RE: Additional Remedial Action Plan (RAP) Information
Former Comedy Club Café
615 E. Brady Street
Milwaukee, Wisconsin 53202
UEC Project No. 17028.5
BRRTS No. 02-41-553001

In a July 3, 2018 letter, Nancy Ryan of the Wisconsin Department of Natural Resources (WDNR) requested additional information from United Engineering Consultants, Inc. (United) prior to approval of the Revised Remedial Action Plan (RAP) report dated May 23, 2018 submitted to the WDNR on May 24, 2018. The following paragraphs discuss the six (6) items outlined in the WDNR correspondence. A summary of each WDNR request is italicized.

Figure 20: Sub-Slab Vapor Mitigation System Component Location Map

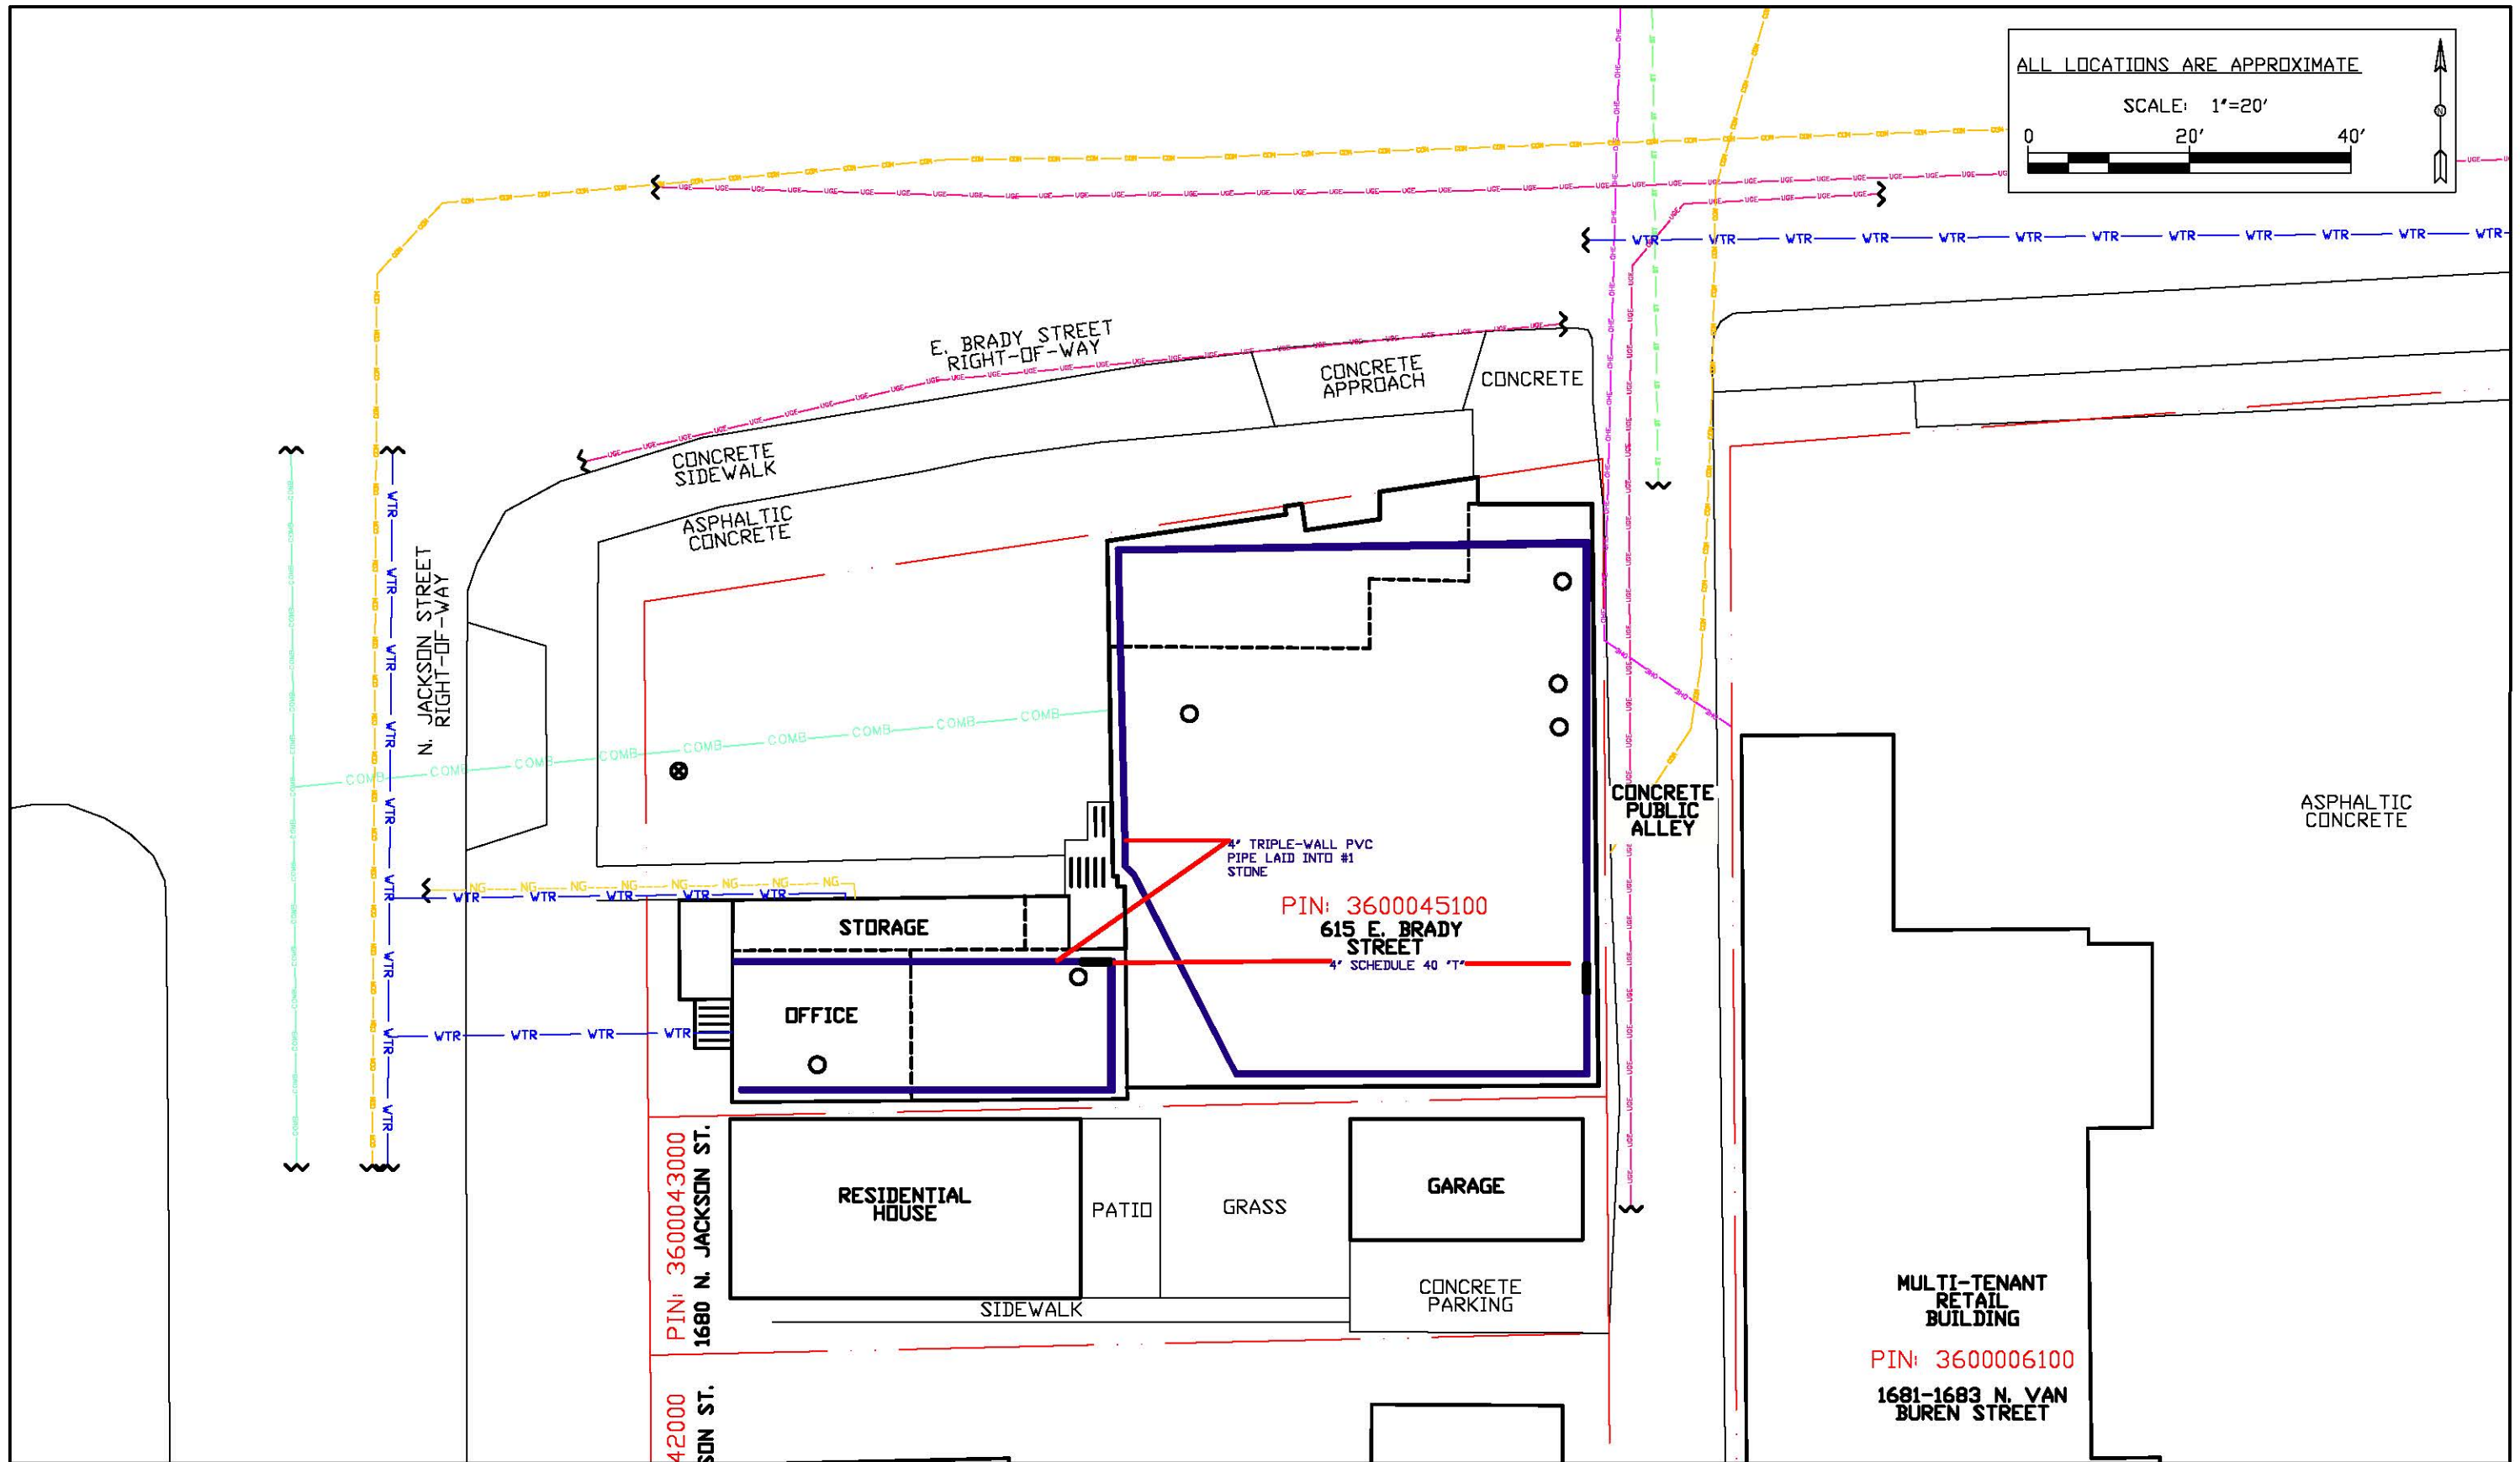
The WDNR requested confirmation that the sub-slab depressurization systems have been installed below the floor slab in the commercial building at 615 E. Brady Street and the basement floor slab in the duplex at 1684 N. Jackson Street. The WDNR stated that following construction and initial operation of the systems, commissioning must be completed for each system to comply with section NR 726.05(g) of the WAC.

In addition, the WDNR indicated that performance verification should be conducted following the guidelines provided in WDNR publication RR-800, Addressing Vapor Intrusion at Remediation and Redevelopment Sites in Wisconsin. The WDNR requested the submittal of documentation of each system design, verification monitoring and base conditions. A system operation, maintenance and inspection plan will also be required since the systems will require operation as a continuing obligation of case closure.

The system for the commercial building consists of four (4) inch diameter triple wall, perforated PVC schedule 40 piping located around the interior foundation perimeter. The holes in the PVC piping face downward and laterally and the piping is surrounded by #1 stone with a minimum of two (2) inches of stone below and adjacent to the piping. Six (6) inches of #1 stone extends across the entire building footprint to insure total air flow beneath the concrete slab (See attached Figure 20: Sub-Slab Vapor Mitigation System Component Location Map). The piping and #1 stone is overlain by twelve (12) inch lapped forty (40) mil polyethylene plastic and a four (4) inch concrete slab. The lapping is caulked and taped.

The horizontal perforated piping is connected to a four (4) inch diameter vertical pipe located at the southeast corner of the proposed commercial structure which extends above the planned roof line to an exterior earth gas fan. One hundred ten (110) volt at 1.5 amp maximum wire extends from the building to a 15A exterior rated outlet installed adjacent to the exterior fan. A manometer is located along the interior of the eastern wall of the commercial structure for monthly inspection.

The system for the duplex consists of four (4) inch diameter triple wall, perforated PVC schedule 40 piping placed in a U shaped trench ranging in width from approximately twelve (12) to twenty (20) inches and about ten (10) to twelve (12) inches in depth (See Figure 20: Sub-Slab Vapor Mitigation System Component Location Map). The holes in the piping face downward and laterally and the piping is surrounded by a minimum of two (2) inches of #1 stone below and adjacent to the piping. The piping is overlain by forty (40) mil polyethylene plastic and a four (4) inch concrete slab.

The horizontal, perforated piping is connected to a vertical four (4) inch diameter PVC pipe located at the northeast corner of the duplex which extends above the planned roof line. The exterior earth gas fan is located at the bottom of the vertical pipe. One hundred ten (110) volt at 1.5 amp maximum wire extends from the duplex to a 15A exterior rated outlet installed adjacent to the exterior fan. A manometer is located along the interior of the northern wall of the duplex for monthly inspection.
